**Architectural Review Committee Staff Report**  
**Department of Planning and Building**  
**Town of McCordsville**

**April 20, 2021**

**Project:** Breedlove Dobbs HVAC

**Request:** The petitioner is seeking approval of architecture for an office/warehouse building.

**Illustrative Architectural Exhibit (from Zoning petition)**

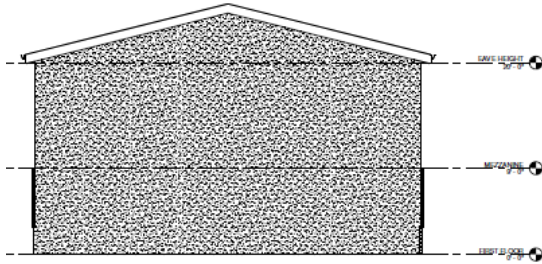
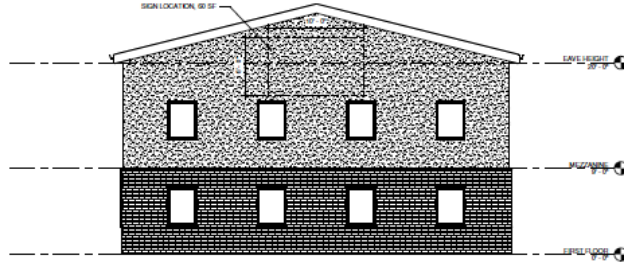
1. Where will ground mounted HVAC equipment be located for the building and how it will be screened?
2. Staff feels there is a scale issue with the front porch. Staff is unsure of the solution but might suggest the ARC provide a recommendation to the petitioner.
3. There is a wall pack denoted on the building elevations that is not denoted in the photometric plan. Staff would like the petitioner to clarify intent.
